Notice of Decision

Site Plan Review and Replat

SP-29-24 & RL-06-24

Proposal:	Site Plan Review to establish a vocational school and a replat to consolidate two units of land.
Review Body:	Staff (Type I-L review)
Report Prepared By:	Jennifer Cepello, Project Planner
Property Owner:	Albany Industrial, LLC; C/O Freddie Hines III; 8625 Evergreen Way, Suite 200, Everett, WA 98208
Applicant:	Simone Duley; 4875 SW Griffith Drive Suite 300, Beaverton, OR 97005
Address/Location:	112 & 124 41st Avenue
Map/Tax Lot:	Linn County Assessor: 10S04W19A Tax Lots 1700 & 1800
Zoning:	Light Industrial (LI)

Sheet Title:
SITE PLAN

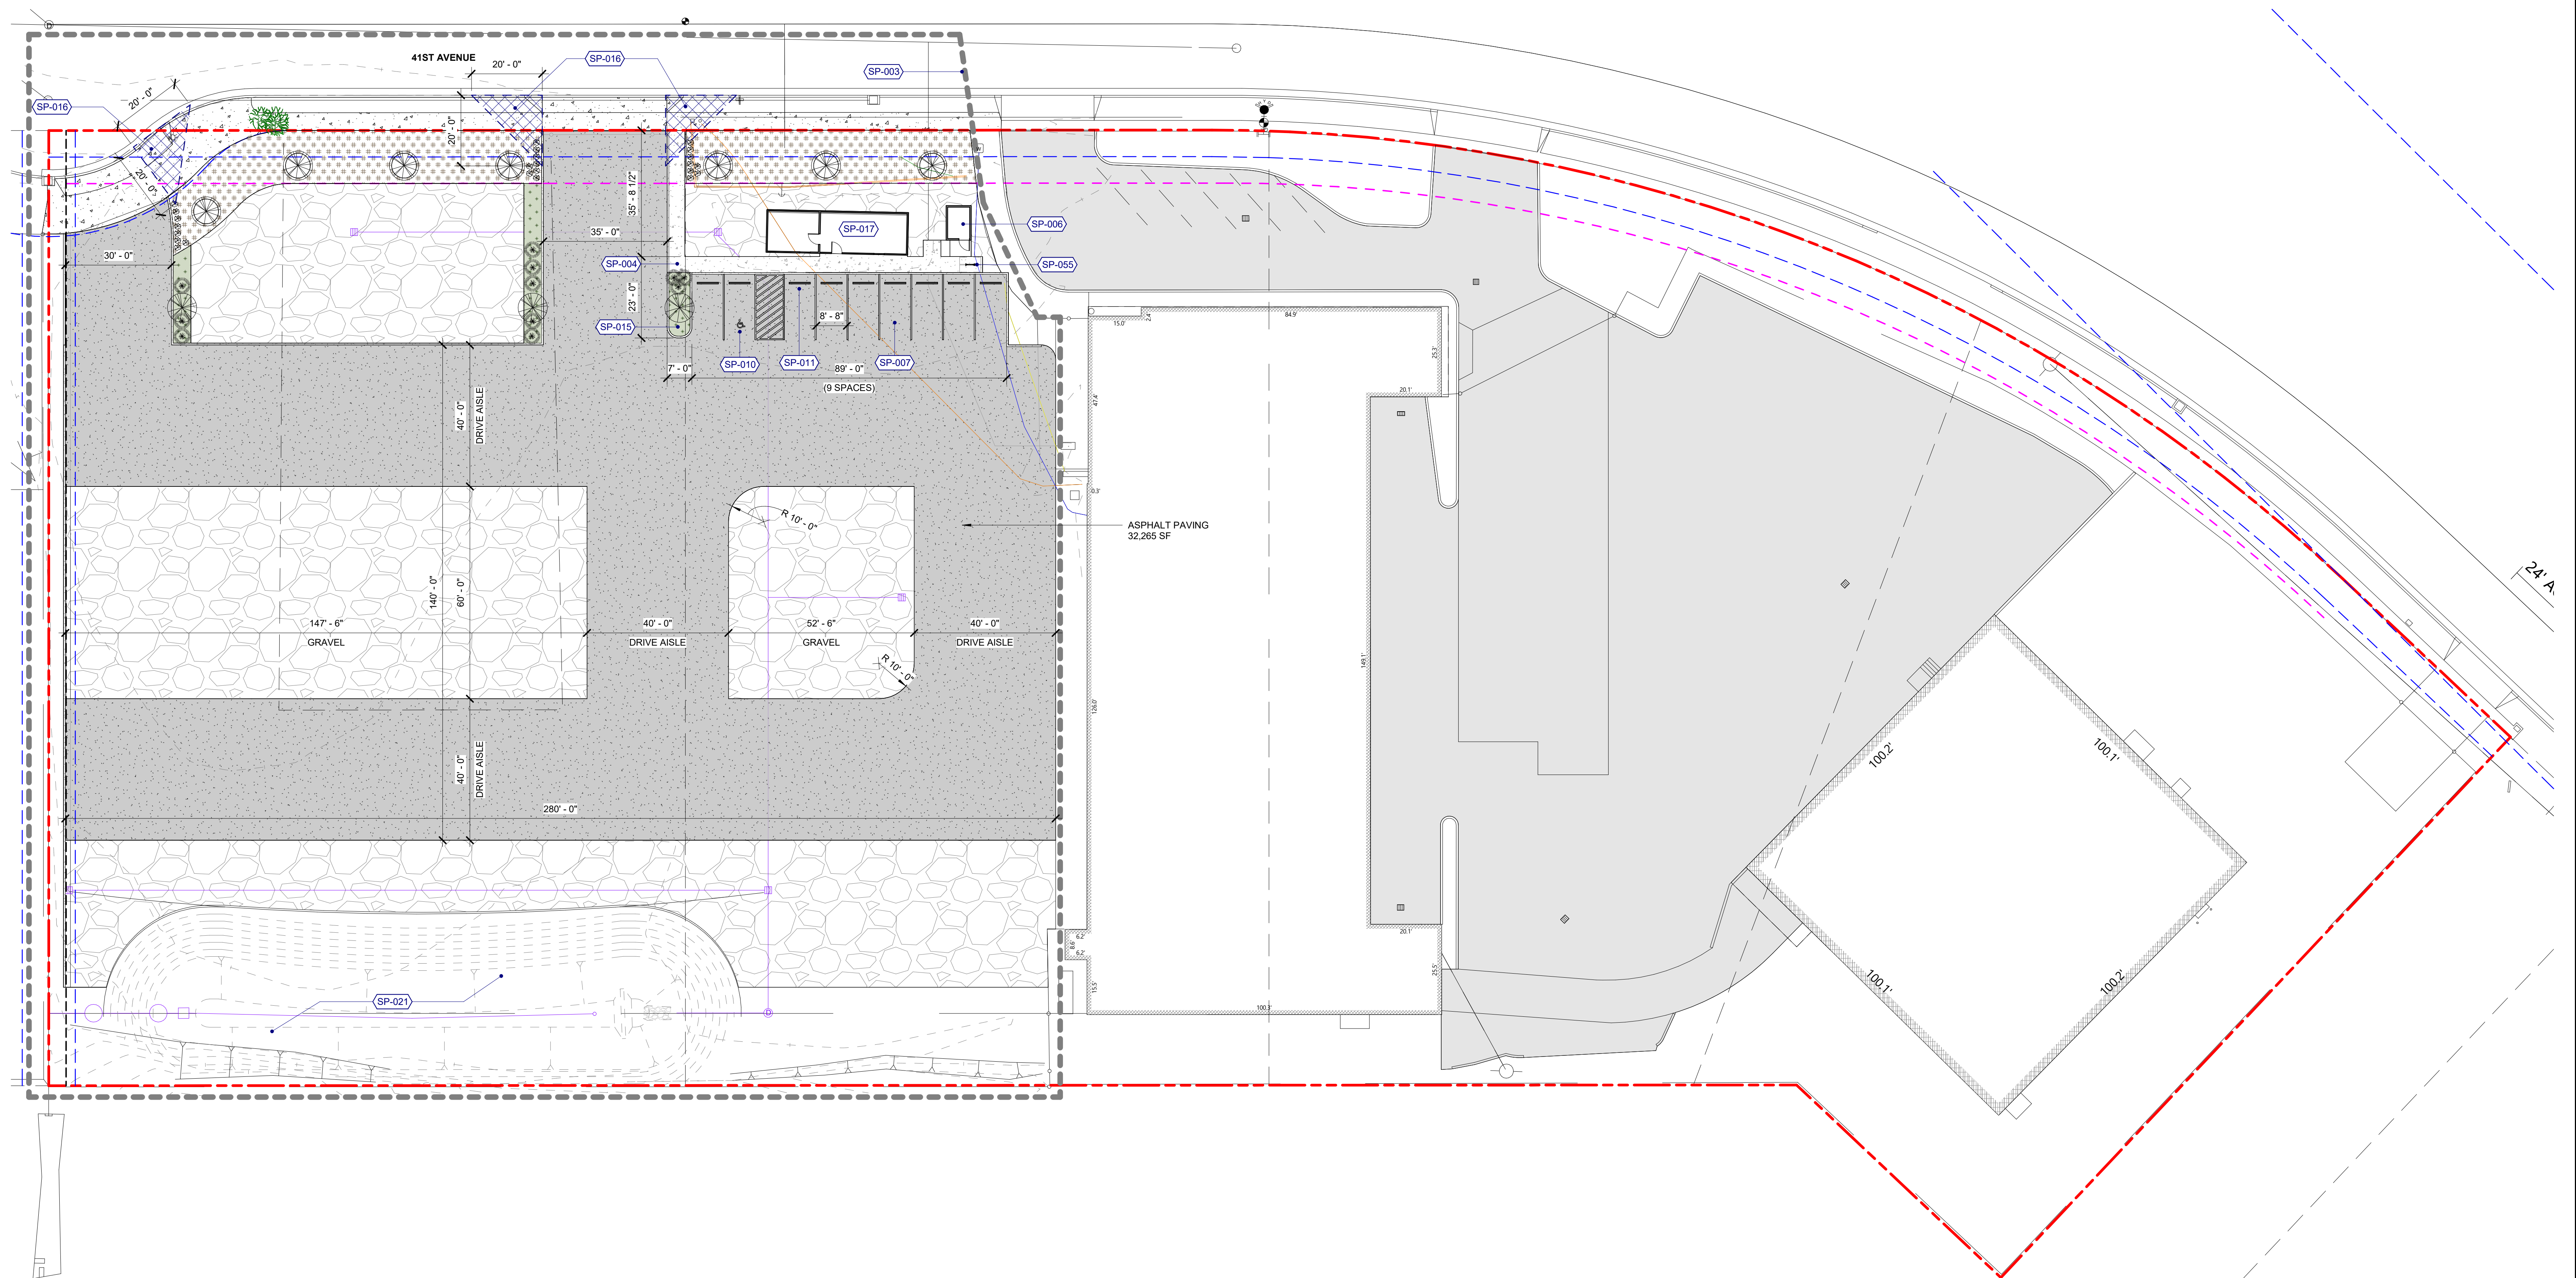
- Condition 1: Prior to the commencement of on-site activity, the electrical service capacity must be installed to serve at least two parking spaces, one of which must be the provided ADA space.

- Condition 5: Prior to commencement of activities of the site, the applicant shall install public sidewalk to city standards along the frontage of the site on 41st Avenue as generally shown on the submitted site plan.

1 BIKE RACK
12" = 1'-0"

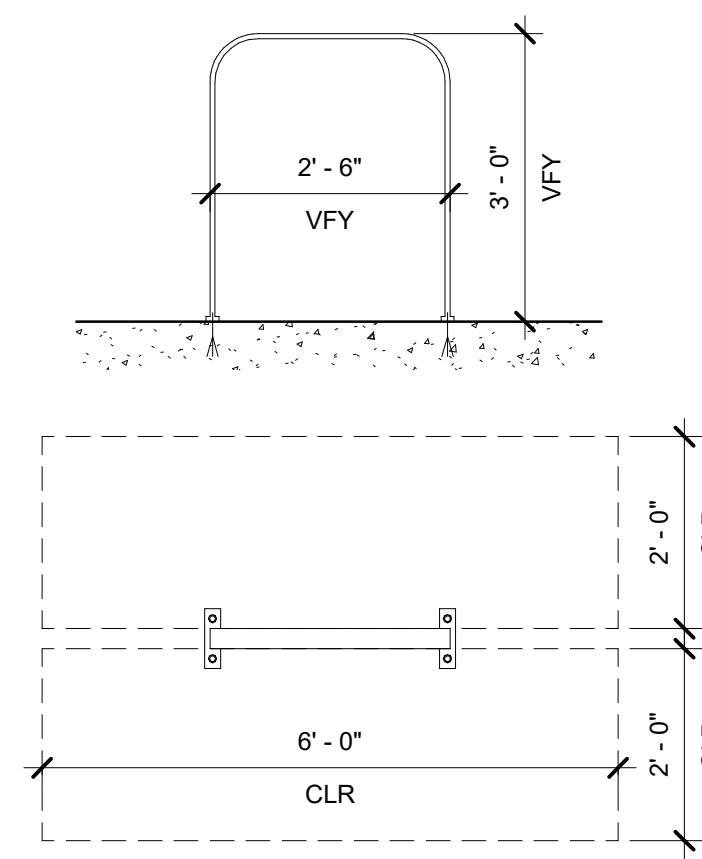
- Condition 2: Prior to the commencement of on-site activities, the construction details of the covered bicycle structure must be provided and meet the requirements of ADC 9.030(4).
